ADDENDUM #1 TO THE PLANS, SPECIFICATIONS, AND CONTRACT DOCUMENTS

HEALTH SCIENCE CAMPUS HSC NEW BUILDING –BID PACKAGE 1
UNIVERSITY OF LOUISVILLE

BP#1 - KDP Demo + Fiber Relocation

E401

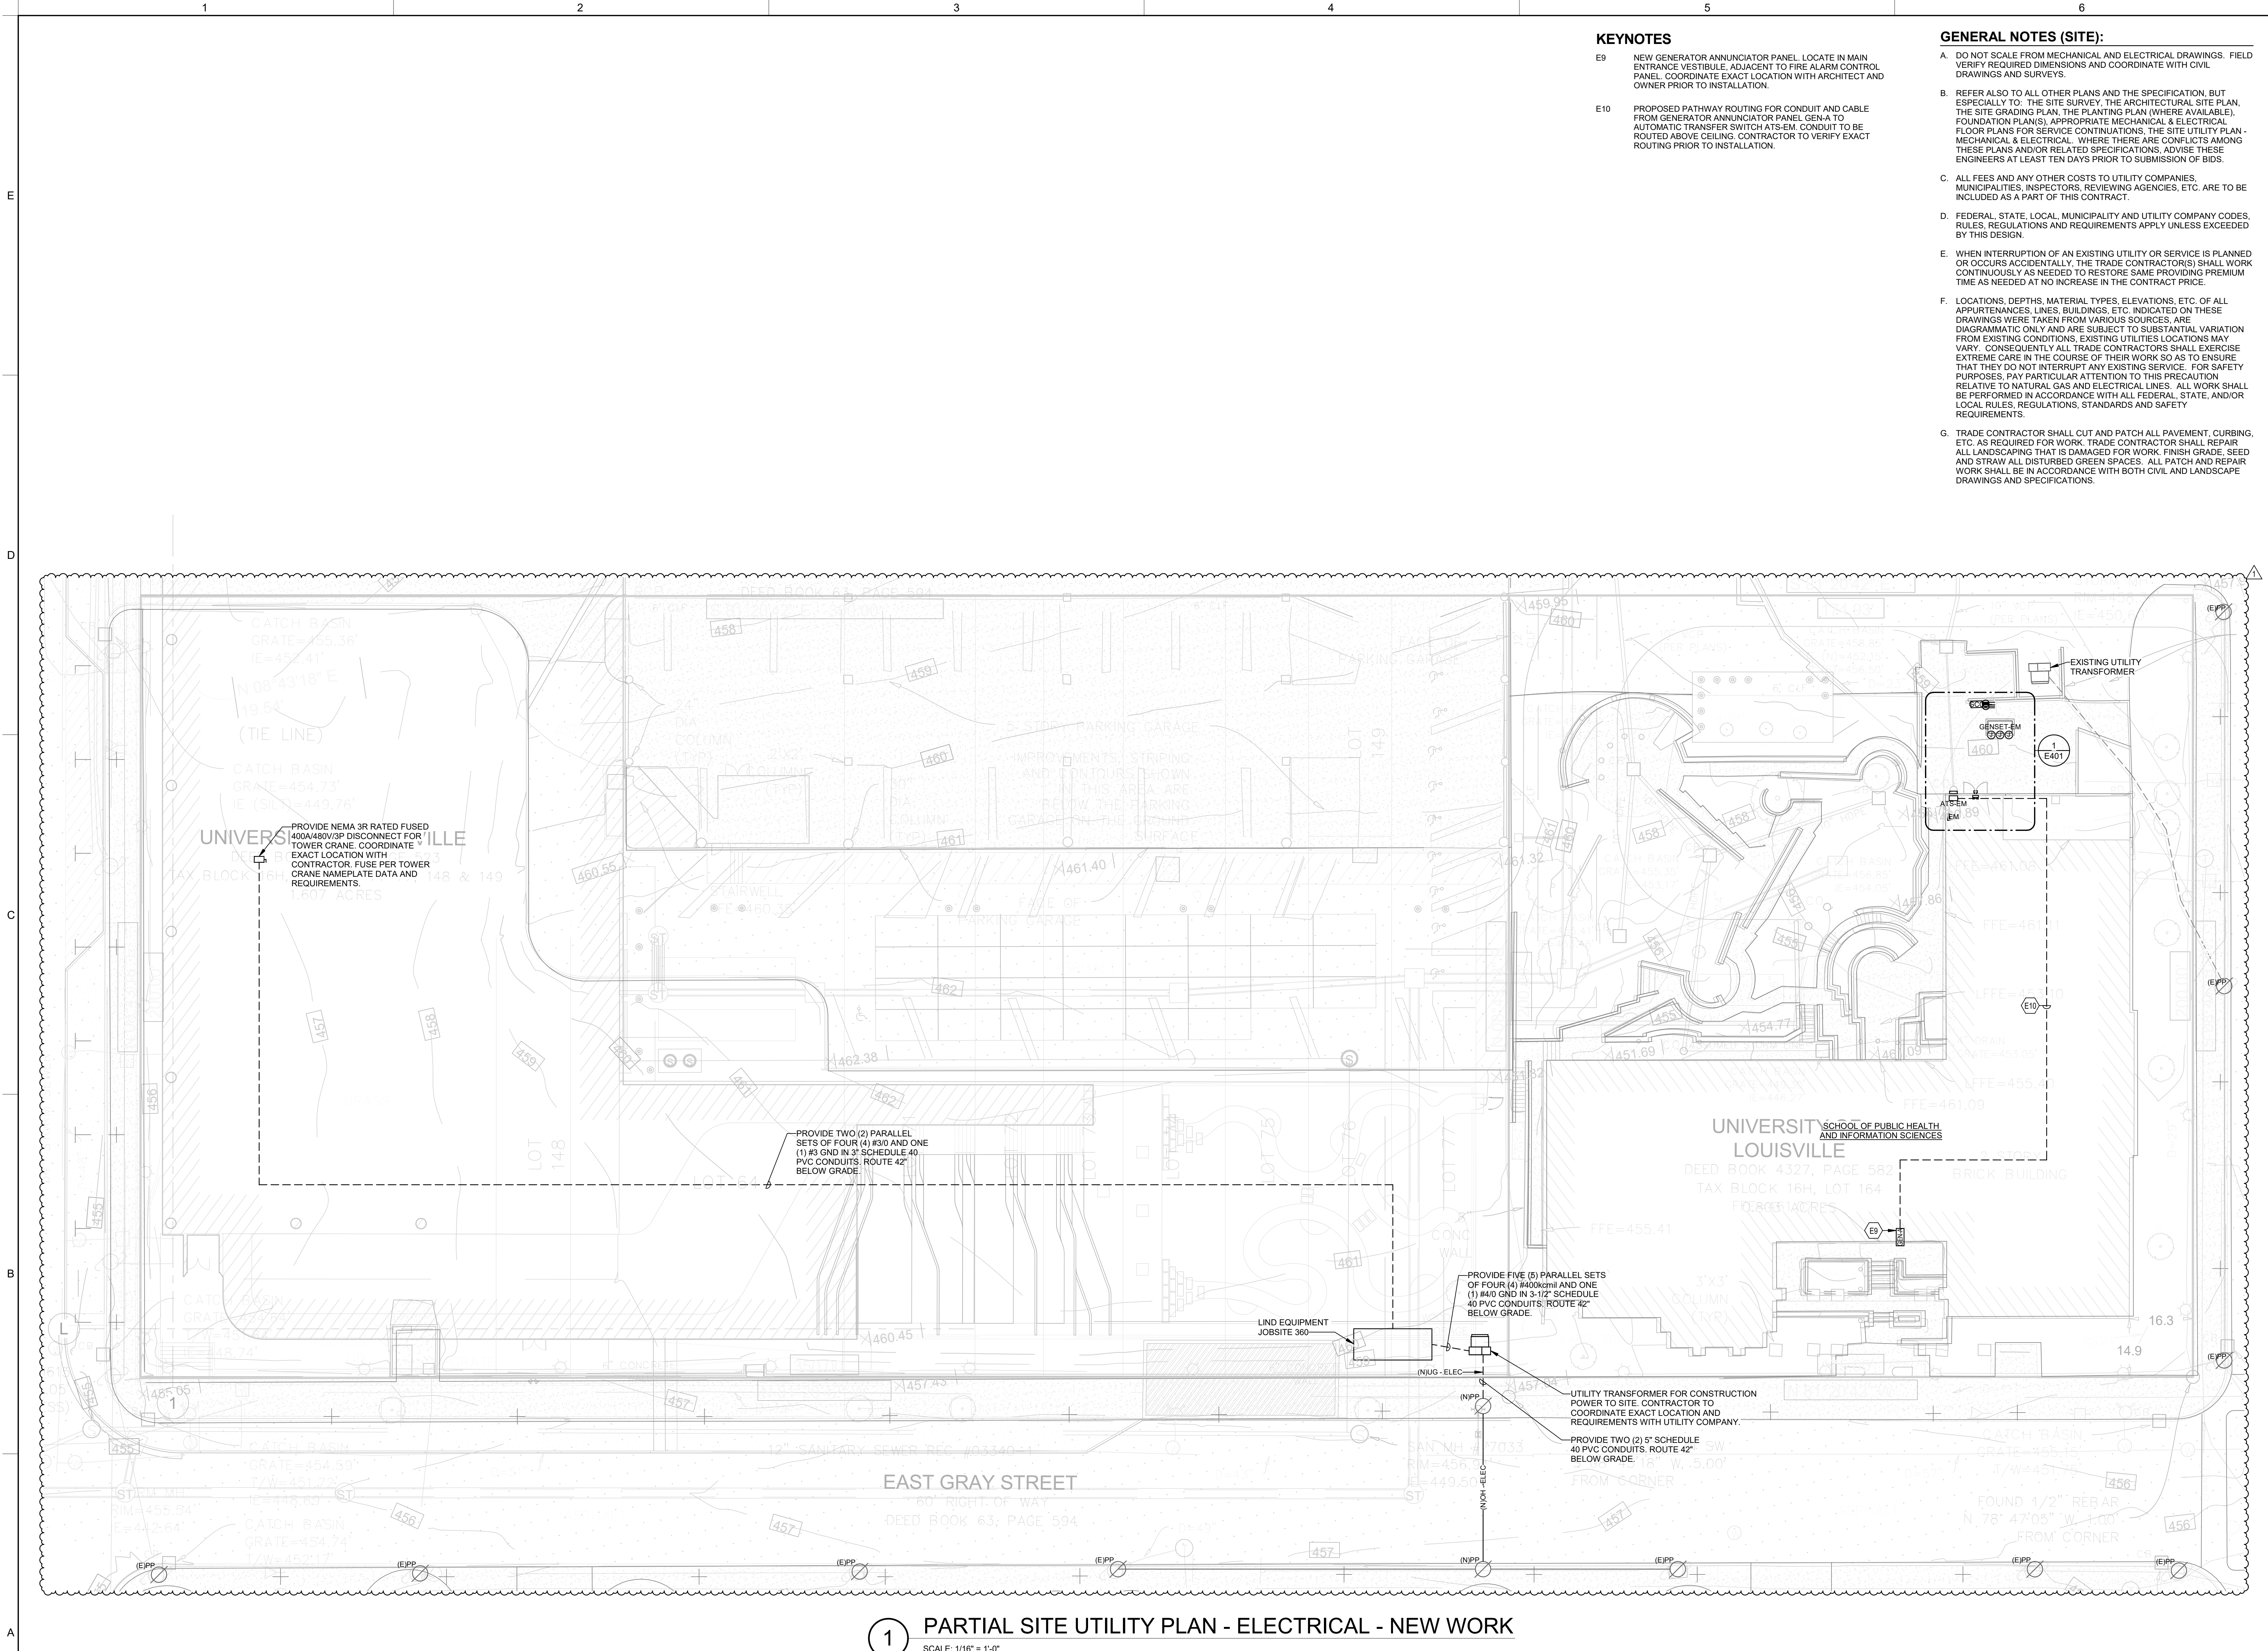
E15 CONCRETE FILLED STEEL BOLLARD. REFER TO DETAIL 5, SHEET E501.
